ECR proudly announces the New and Improved *GTMA 3 Position Gas Furnace*. ECR International is committed to producing products that satisfy the needs of our installers and homeowners. This next generation of mid efficiency gas furnace is proof of that commitment.

What has improved?

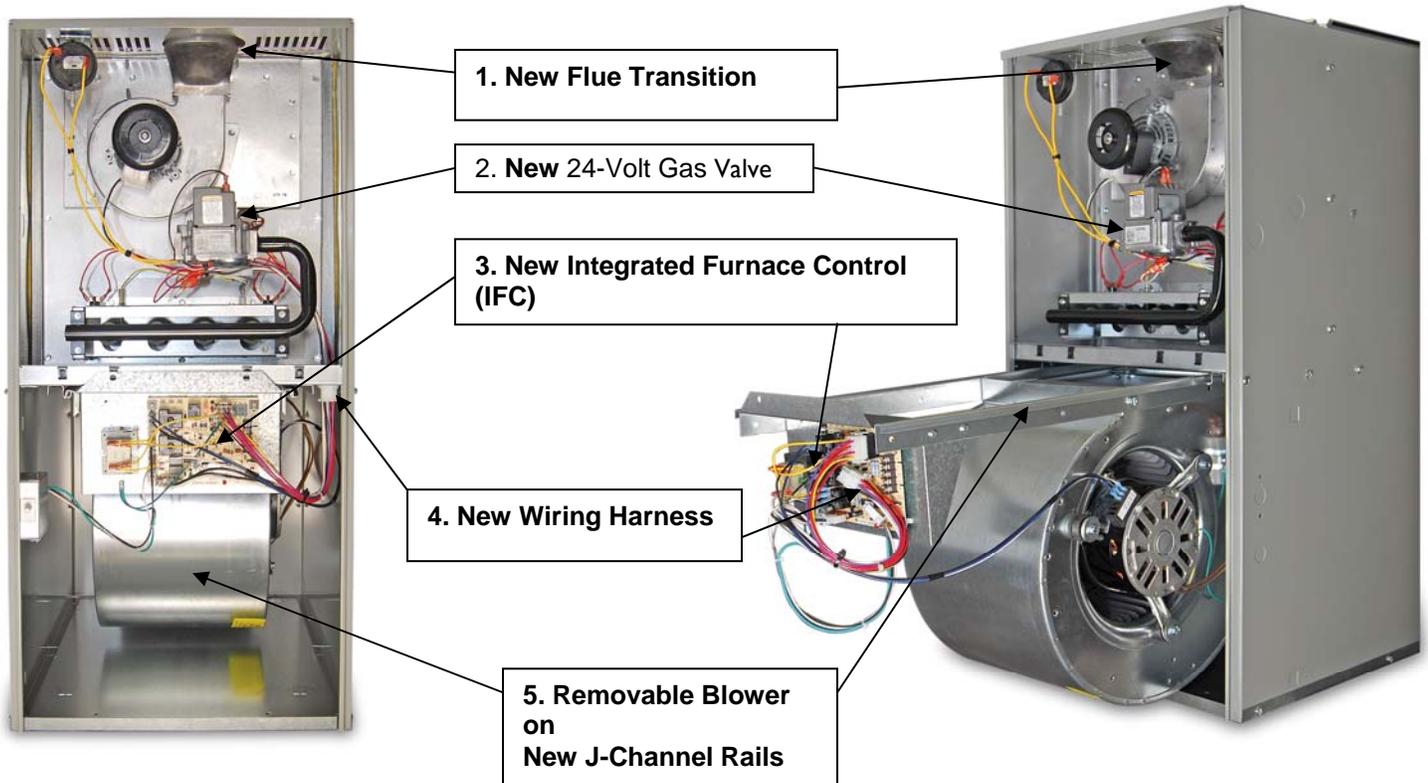
1. New Flue Transition – is now a seamless cast aluminum component with less opportunity for leaks making the unit safer. The new shape is less restrictive reducing demand on the draft inducer.

2. New 24-Volt Gas Valve – replaces the Honeywell Smart Valve II. The 24-volt valve is a universal industry standard making the furnace more service friendly and familiar to installers.

3. New Integrated Furnace Control (IFC) - constantly monitors all safety devices and controls all aspects of the furnace. The sophisticated control center contains L.E.D. service lights with 11 self-diagnostic service codes (5 more than smart valve II) to ensure quick and accurate service calls. Connection of additional home comfort products (air conditioning, electronic air cleaner and humidifiers) is easy with simple plug in connections. The IFC has been mounted between the blower rails so that it is easily accessible in upflow and horizontal positions. This also reduces potential vibration (some competitors mount directly to the blower), and the IFC can be detached without removing the entire blower assembly. The IFC is fused for protection of the board and transformer from electrical faults.

4. New Wiring Harness - was revised to make removal and service of the blower assembly quick and easy. The plugs are matched to ensure that the correct wires are replaced to the proper location when the blower is reinstalled or service is complete.

5. Removable Blower on New J-Channels – makes the blower rails more rigid. This is most beneficial when the furnace is installed in the horizontal positions. The blower slides out easily for servicing with no twisting of the rails.
